BOSTON EDISON COMPANY
GENERAL OFFICES 600 BOYLSTON STREET
BOSTON, MASSACHUSETTS 02199

BECo. Ltr. #82-261

License No. DPR-35
Docket No. 50-293

Additional Information on
Block Walls (IE Bulletin 80-11)

Figure 1

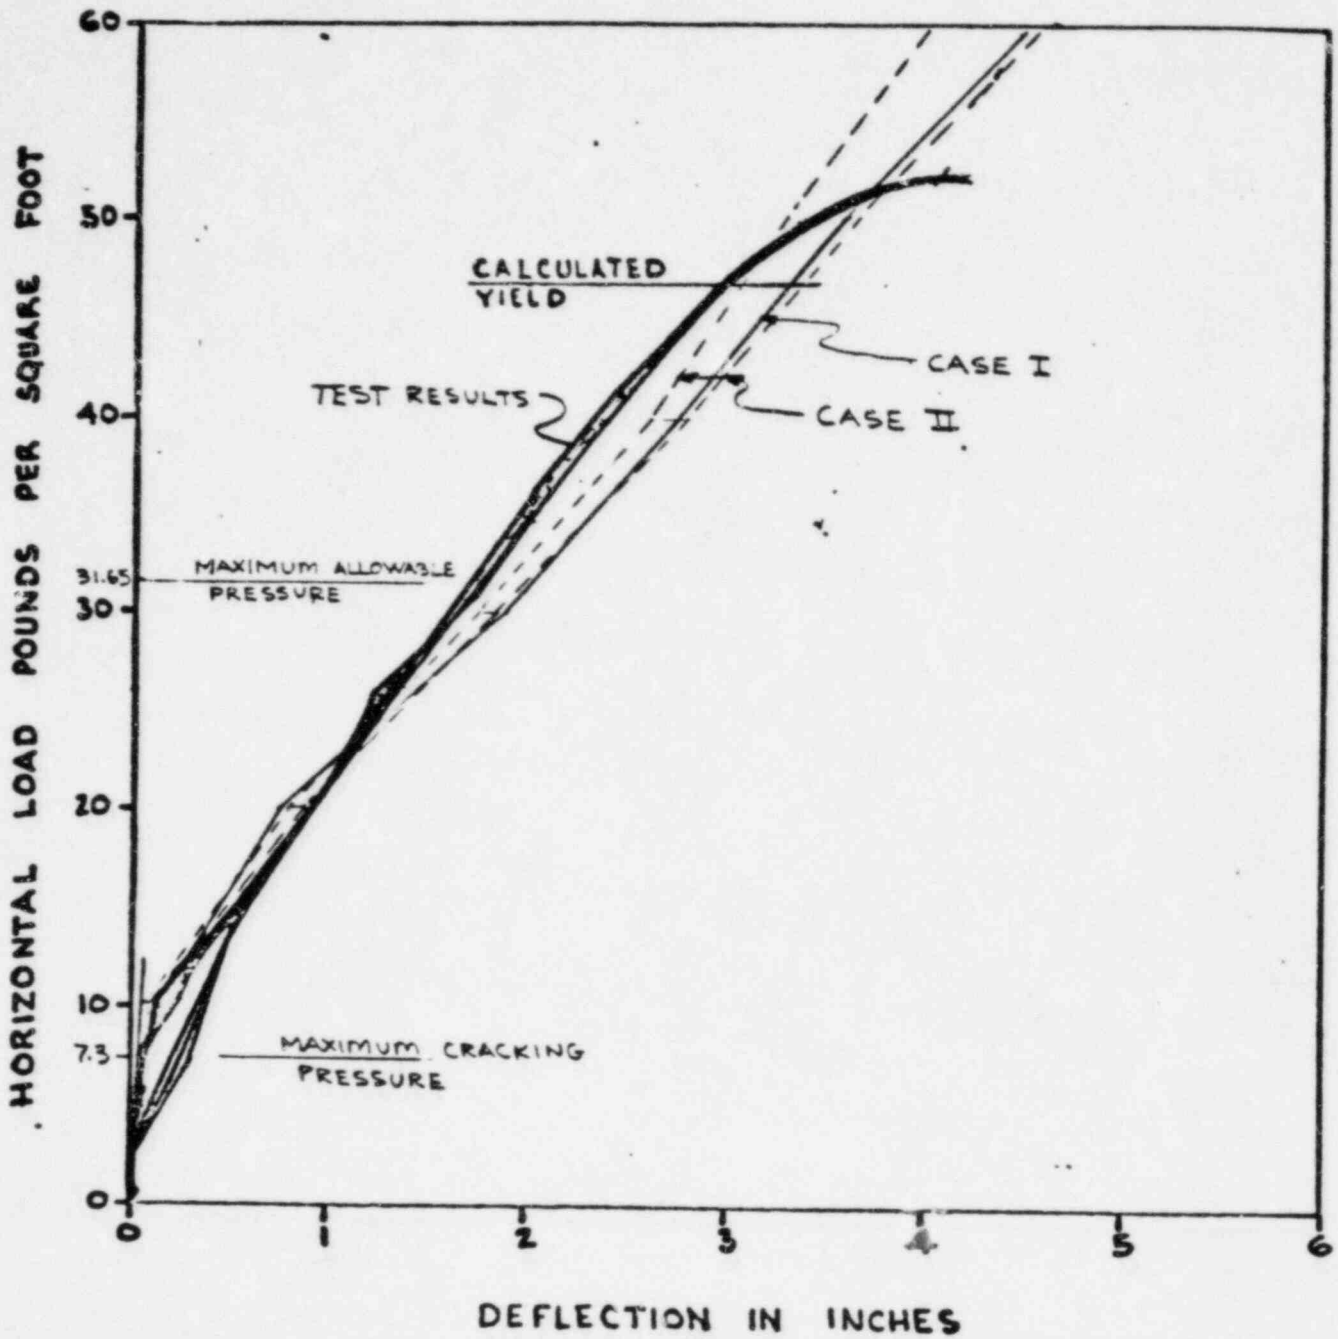
Request 3: Verify the use of the fourth order Branson Formula for computing effective stiffness.

A study was performed to show that Branson Formula is appropriate to use for computing the effective stiffness of concrete block walls. Hand and computer analyses were compared to test results. The test results were obtained from report - Results of Variation of "b" or Effective Width in Flexure in Concrete Block Panels, Masonry Institute of America, reprinted in 1971.

Both third and fourth order Branson Formulas were used for the analysis per the recommendation of ACI Committee 435, articles ACI 435.6R-74 and ACI 435.2R-66. Displacements were calculated using the same pressure loads as the test report. For the third order formula, the displacements were calculated by hand. For the fourth order formula, the displacements were calculated using the SAP IV computer program.

The results show that the Branson Formulas predict the displacements close to the test results. As the moment approaches the allowable, Branson's Formulas are conservative by producing larger displacements than the test results show (see Figure 1).
